Memorandum

Date: May 17, 2017
To: Transportation Authority Board
From: Eric Cordoba – Deputy Director for Capital Projects
Subject: 06/13/17 Board Meeting: Modification of the Geary Corridor Bus Rapid Transit Project Locally Preferred Alternative

Addendum to Environmental Impact Report

Project Title: Geary Corridor Bus Rapid Transit Project

Figure 2. Hybrid Alternative Bus Lane Configuration Change between 26th and 28th Avenues Proposed in the Final EIS

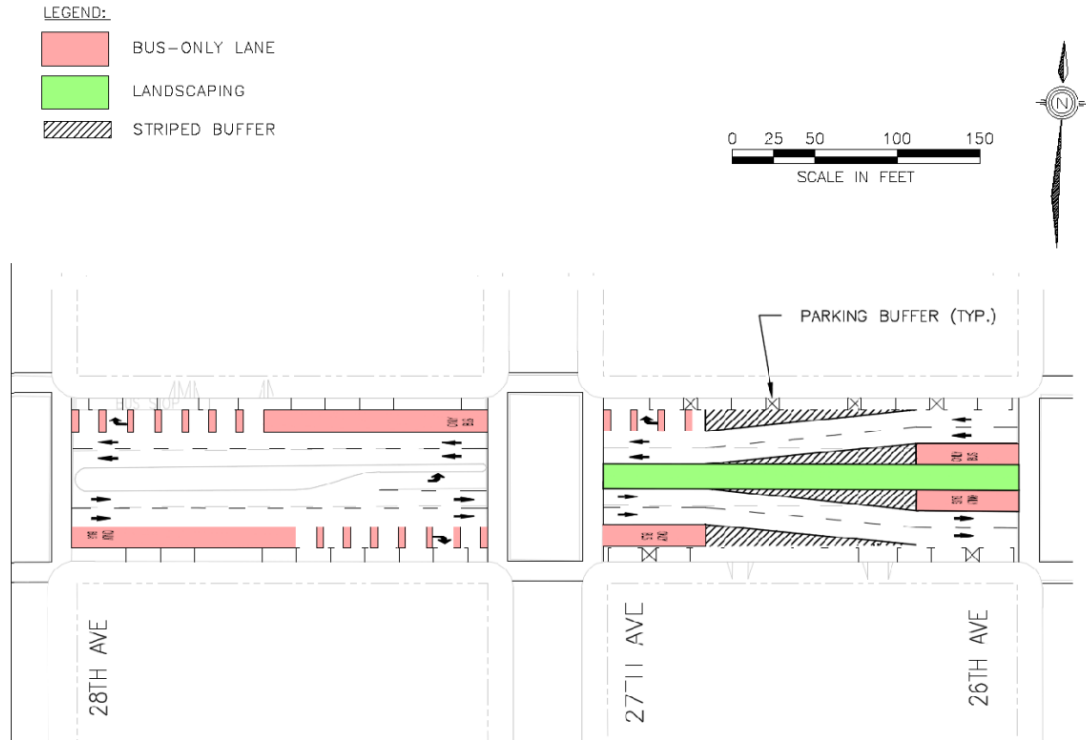
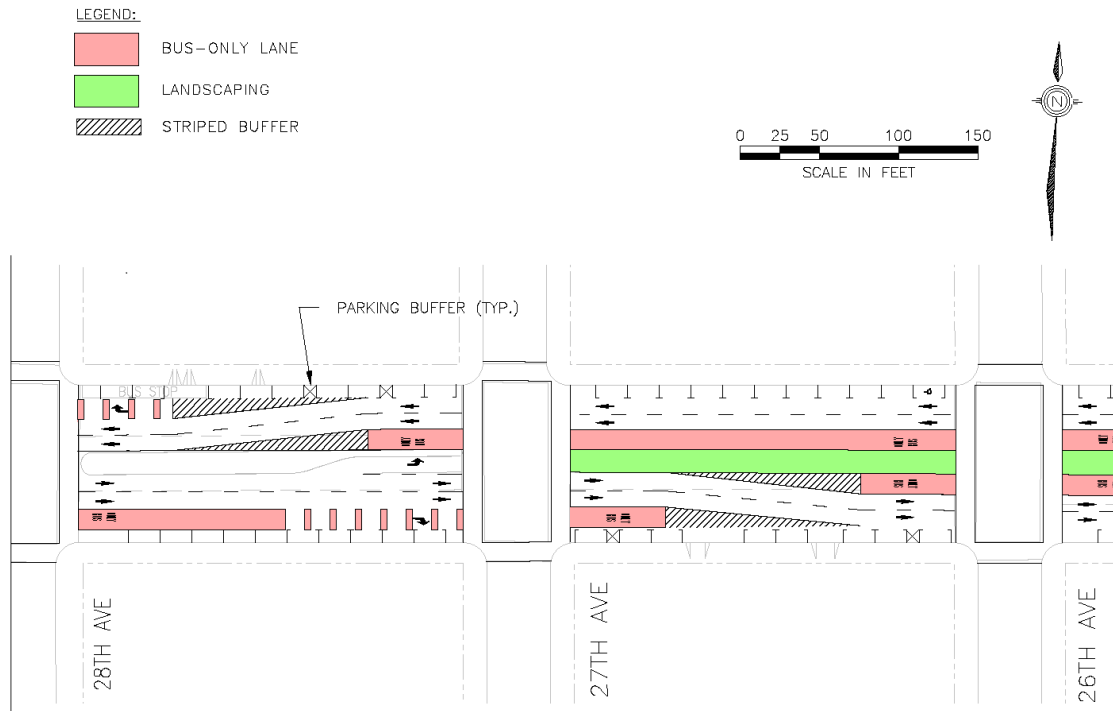
The Project as described in the Draft EIS/EIR and Final EIR assumed a transition from center- to side-running bus lanes in the Outer Richmond neighborhood between 26th and 27th Avenues (see Figure 1). As shown in Figure 1, both eastbound and westbound buses were proposed to transition to or from center/side-running lanes between 26th and 27th Avenues.

As proposed in the Draft EIS/EIR and Final EIR, this design would eliminate nine of the 18 existing angled on-street parking spaces on the north side of Geary between 26th and 27th Avenues due to a combination of the conversion of existing angled spaces to parallel spaces and installation of buffer areas between spaces. On the north side of Geary between 27th and 28th Avenues, the design as proposed in the Draft EIS/EIR would add one parallel parking space to the existing seven parallel parking spaces (eight parallel spaces would result).

The northern side of the block between 26th and 27th Avenues is occupied by the Holy Virgin Cathedral (6210 Geary Boulevard), a religious and community facility. To better accommodate the parking and loading concerns of the facility, the agencies have proposed to modify the transition, as shown below in Figure 2.

As shown in Figure 2, the *westbound* transition would shift one block to the west, to the block between 27th and 28th Avenues. In other words, the center running bus lane would continue for one additional block west. Buses would therefore transition from center running to side running lanes between 27th and 28th Avenues.

To achieve the proposed modification depicted in Figure 2, the following changes to roadway striping aspects of the approved project would be necessary.

- Additional red roadway coloring (denoting a bus-only lane) in the westbound innermost (closest to center) lane for approximately one third of Geary between 27th and 28th Avenues.
- Striping of parking buffers on the north side of Geary between 27th and 28th Avenues, instead of between 26th and 27th Avenues as previously proposed, resulting in the provision of two additional parking spaces between 26th and 27th Avenues.

In addition to the proposed physical shift in bus-only lanes, the proposed modification shown in Figure 2 would require operational changes to transit signal timing/queue jumps.

Prior to the proposed modification, the westbound transit signal queue jump was to have been located at 26th Avenue; eastbound, the queue jump was to have been at 27th Avenue. With the proposed modification, both transit signal queue jumps would be located at 27th Avenue. Based on analysis conducted by SFMTA, this change in queue jumps would not require any change to pedestrian signal timing at either 26th or 27th Avenues. Indeed, the consolidation of both queue jumps to one intersection would allow for more efficient signal coordination.

No parking buffer areas would be installed on the north side of Geary (immediately adjacent to the Cathedral) between 26th and 27th Avenues, thus preserving two additional parking spaces (retaining 11 of the existing 18 spaces). With this design, the number of parking spaces remaining on the north side of Geary between 27th and 28th Avenues would not change relative to the project as proposed in the Draft EIS/EIR and the Final EIR: a total of eight parallel spaces, an increase of one space over existing conditions.

The *eastbound* transition would remain as proposed in the Draft EIS/EIR and Final EIR, between 26th and 27th Avenues on the south side of Geary Boulevard. No modification to the eastbound transition is proposed.

The proposed modification would retain the existing planted median between 27th and 28th Avenues. The proposed modification would not increase the need for excavation or median removal relative to what was disclosed in the Draft EIS/EIR and Final EIR.

Figure 3: Proposed Construction Phasing

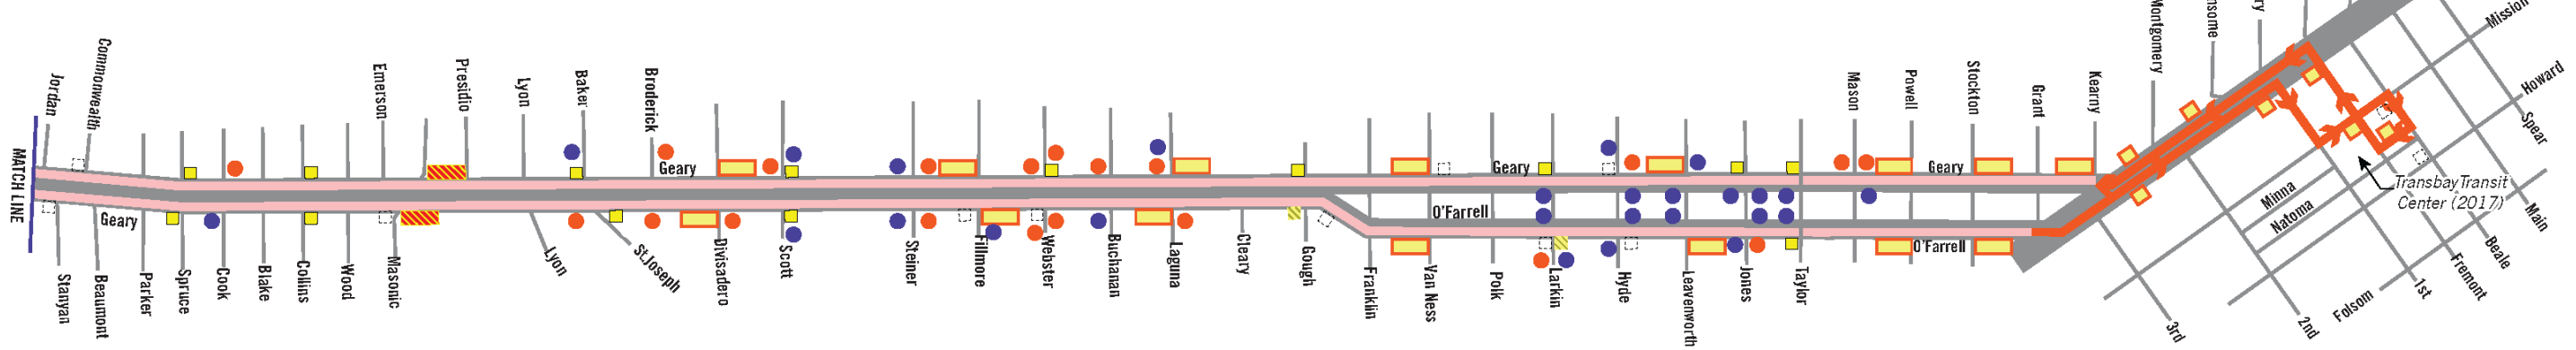
As illustrated in Figure 3 below, Phase I would entail work east of Stanyan Street where BRT would operate in side-running bus-only lanes. Phase II would include work west of Stanyan Street, where BRT operations would be in predominantly center-running bus-only lanes.¹ The project would still be constructed using the Staggered Multiple Block Segment Approach described in Section 4.15 of the Draft EIS/EIR.

Phase I and Phase II would *each* be expected to take approximately 100 weeks, including both active and inactive periods and anticipated separate utility work. With more information now available with regard to specific phasing activities and SFMTA's recent experience with similar projects, the duration of construction activities on any given block could take up to 12 months for areas with a larger scope of work inclusive of active and inactive periods, depending on construction scheduling, construction operations, and the extent of the utility work involved. The majority of blocks would have a shorter anticipated construction duration.
